GROUP	MODEL
	BOD	2024-2025MY EV9 (MV1)
	NUMBER	DATE
	341	July 2025
TECHNICAL SERVICE BULLETIN		
SUBJECT: CONSOLE ARMREST LOWER COVER AND BUMPER REPLACEMENT

This bulletin provides information to replace the console armrest lower cover and bumpers on some 2024-2025MY EV9 (MV1) vehicles produced from July 27, 2023 through April 26, 2024. The affected vehicles may exhibit console armrest wobbling and/or rattling when closed. One or both bumpers can be missing, broken, and/or shifted out of place creating a gap between the console armrest and the console assembly which causes the console armrest to wobble and/or rattle while closed. To rectify this concern, follow the procedure outlined in this publication to replace the console armrest lower cover and bumpers on the applicable vehicle.

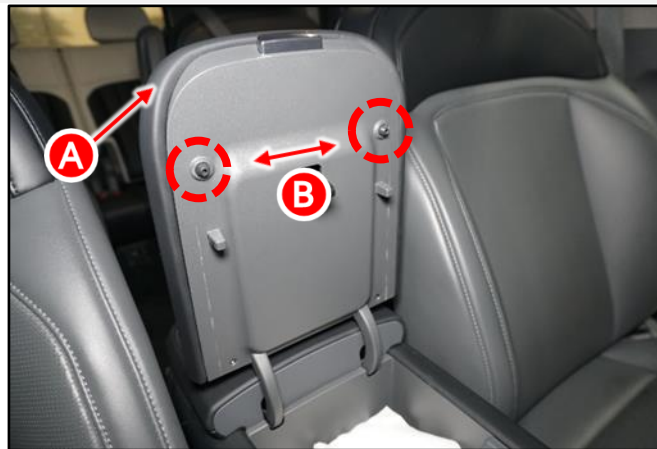
1. Open the console armrest assembly (A).
2. Remove the console armrest assembly bumper(s) (B).

3. Loosen the five (5) retaining screws.

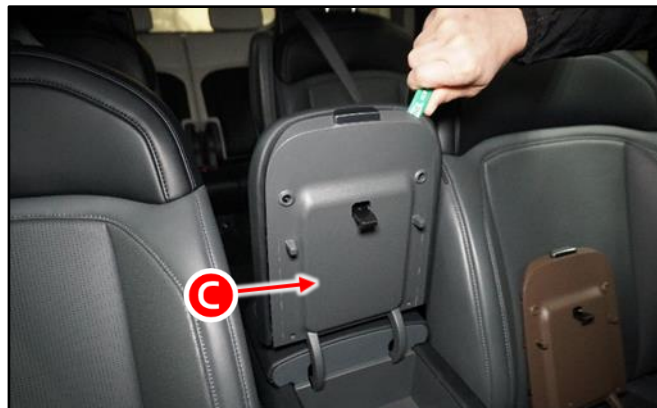
- 4a. Using a non-marring trim removal tool, separate the console armrest lower cover (C) from the console armrest assembly (A).

- 4b. Install the new console armrest lower cover (C).

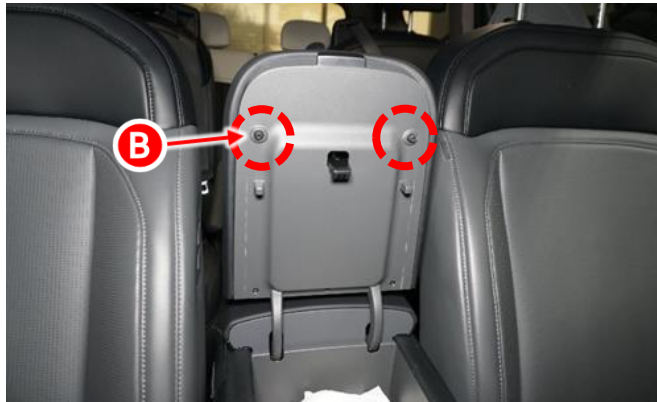
5. Install the new console armrest assembly bumper(s) (B).

6. Confirm normal console armrest operation.
